California High-Speed Rail Authority

# ***San Jose to Merced Project Section***

**Responses to Comments on the Draft  
Environmental Impact Report/  
Environmental Impact Statement and  
Revised/Supplemental Draft  
Environmental Impact Report/  
Environmental Impact Statement**

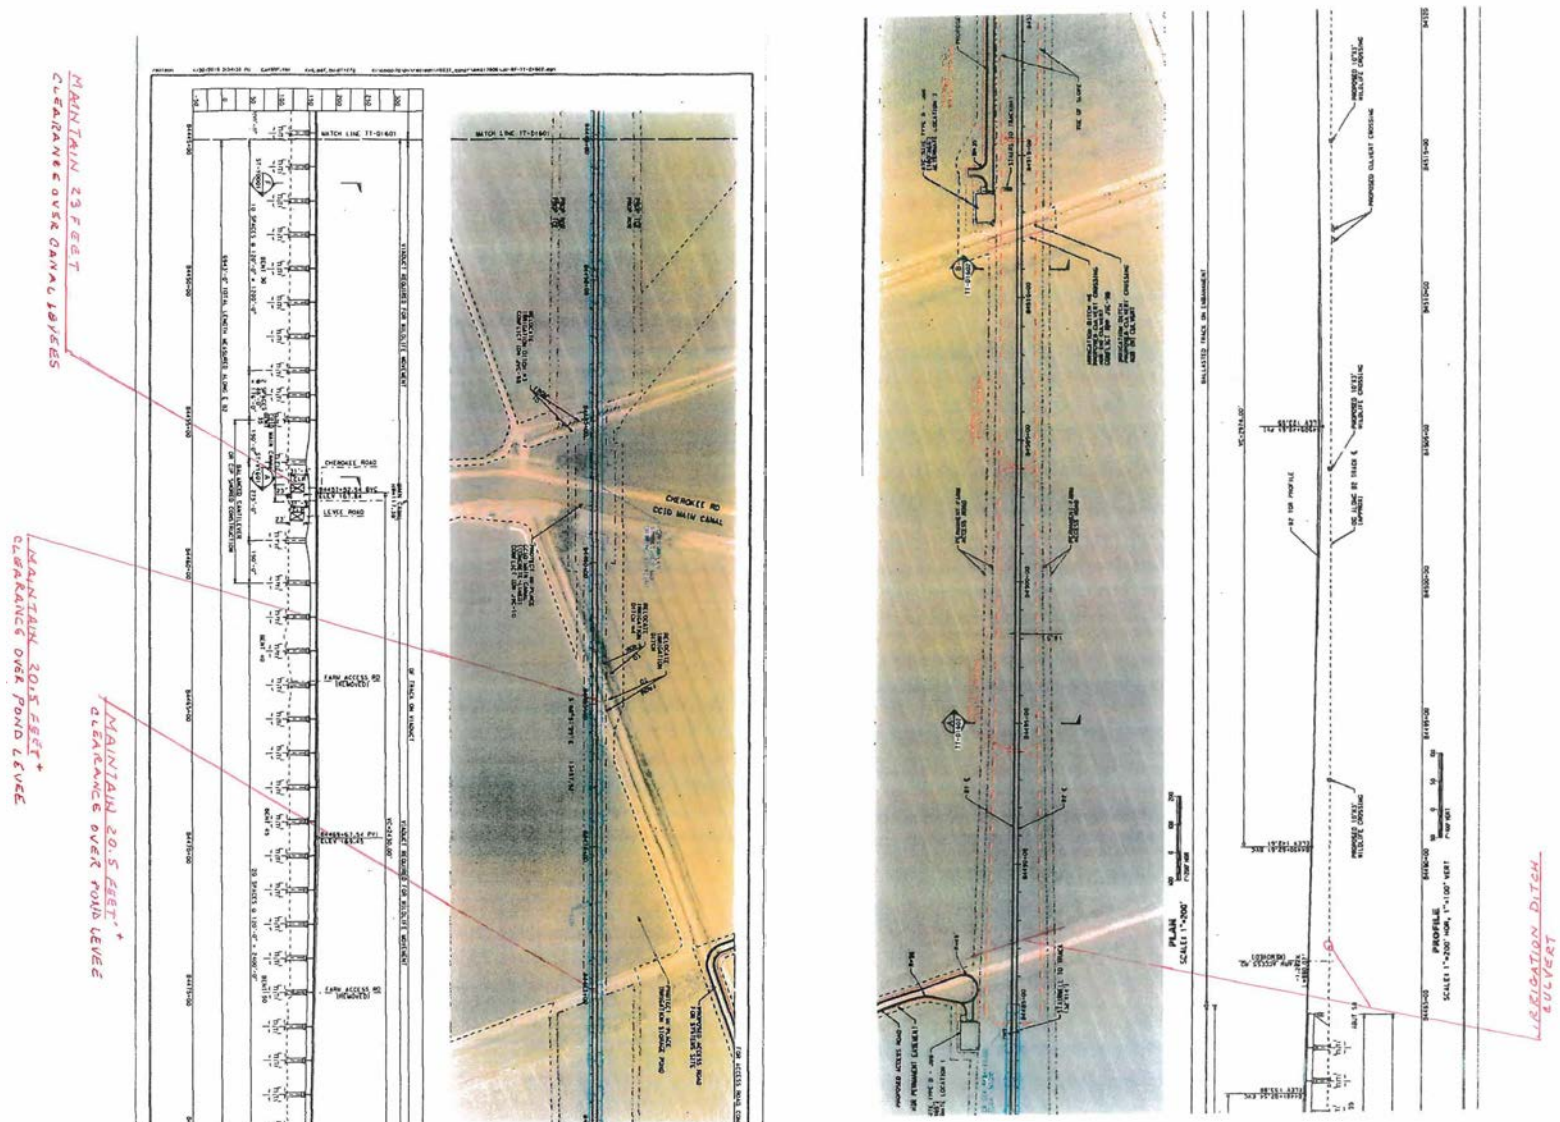
MAINTAIN 23 FEET  
CLEARANCE OVER CANAL LEVEES

**Figure 1**  
**Mistakes Regarding Off-Site Parking Spaces SAP Center Customers are Allowed to Use During BART Construction**

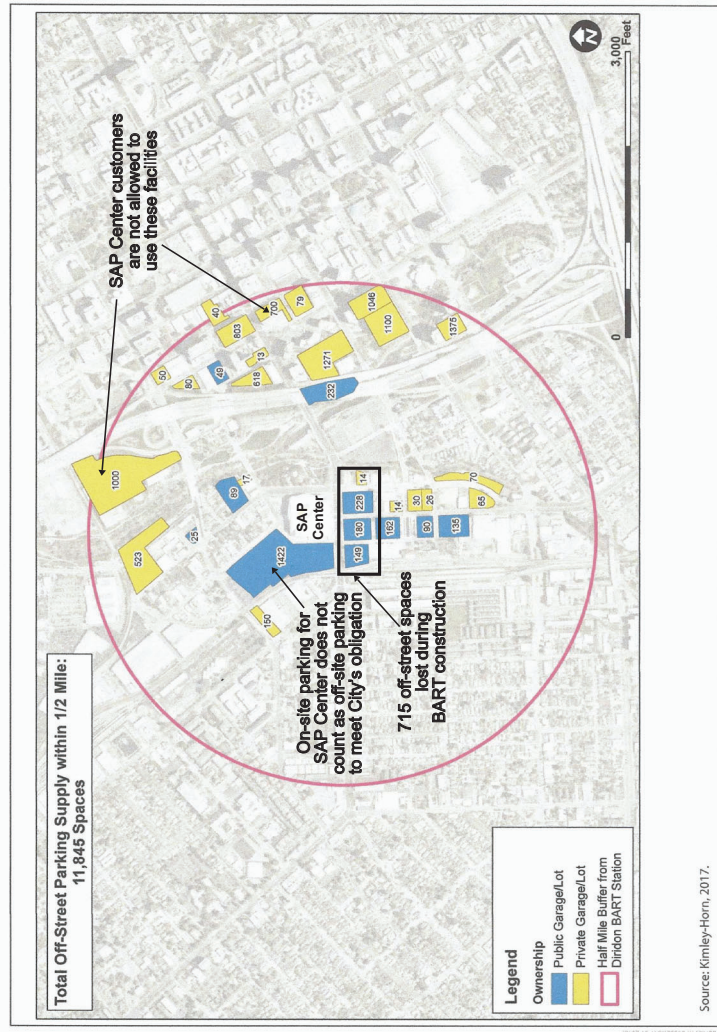
Beyond this huge mistake in Figure 5-H, another factor that would reduce the number of available on-street parking spaces is restricted time limits that are posted for some of the spaces. For example, spaces along The Alameda are posted with a time limit that prohibits SAP Center customers and transit users from parking in these spaces. All of the above factors, occupancy of spaces, reserved spaces, spaces that are restricted to particular users, residential parking permit areas, posted time limits, etc. are critical for completion of valid parking impact studies. The failure of the Final SEIS/SEIR to account for these factors results in invalid and unusable conclusions. The consequence of this oversight is that off-street and on-street parking spaces truly "available" during weekday daytime hours, on weeknights, and on weekends are significantly less than cited in Master Response 2.
